DRAGONFLITE 95 RESTRICTED CLASS RULES v1.2

Detail and explanation of changes made in Version 1.2 Rules issued on 25th October 2106

New, adjustable string to improve location of Mainsheet Bridle Ring.

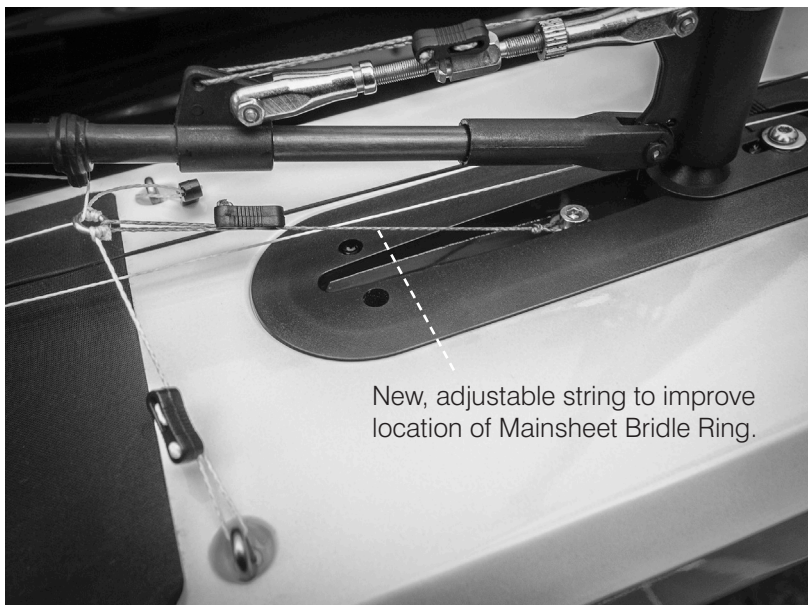
This a new Rule, in two parts:

The stainless steel ring supplied by the builder may be substituted by any similar ring. The ring as supplied with the boat can have sharp corners that chafe through the mainsheet cord very quickly, so you are now allowed to substitute this ring with one of a similar size having a more radiused cross section.

A third cord may be fitted to secure the position of the ring. It's front end shall be fastened around the head of the keel bolt and then lead back around the ring with a bowsie adjuster. Currently, the ring is located by adjustable cords to the deck eyes at each side of the boat. A third, adjustable cord lead forward and located around the head of the keel bolt will prevent the ring from sliding back beyond the position of the sheeting eye on the boom. This means the mainsheet is being pulled in at the optimum angle from the boom, reducing the load on the sailwinch. See photo below illustrating the installation of this third cord.
